SERVICE LETTER 223

Scout 8GCBC Hydraulic Pump Replacement on 2100A Floats

Aircraft Makes/Model(s):	Float Model(s):	Compliance: Optional	By: MAB
American Champion Scout 8GCBC	2100A	Part Number: 1011772	Approved: SDW
		Date: 5/7/2021	Revision: A

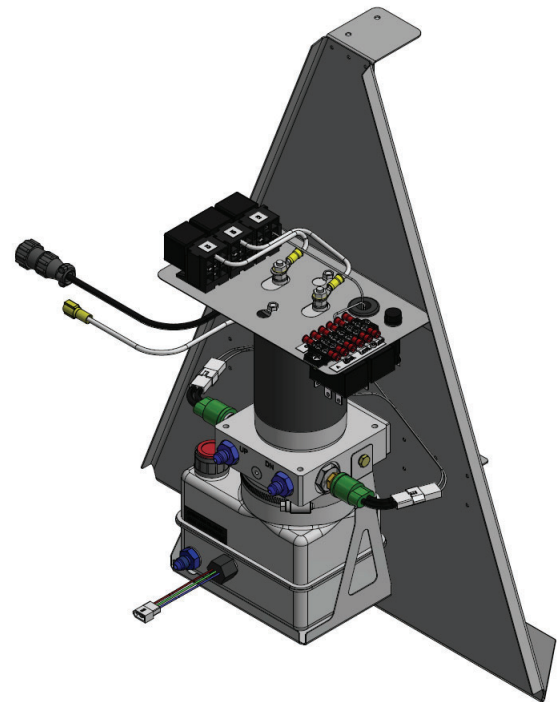
The Hydraulic Pump Assembly p/n 21A09000-216 has been discontinued. This service letter provides the option to replace it with pump p/n 1011760.

DISCONTINUED
HYDRAULIC PUMP 21A09000-216

NEW
HYDRAULIC PUMP 1011760

8. Unbolt and remove hydraulic power pack 21A09000-216 from MS21919DG14 clamps.
9. Install new hydraulic power pack 1011760 with new MS21919DG14 clamps using existing hardware.
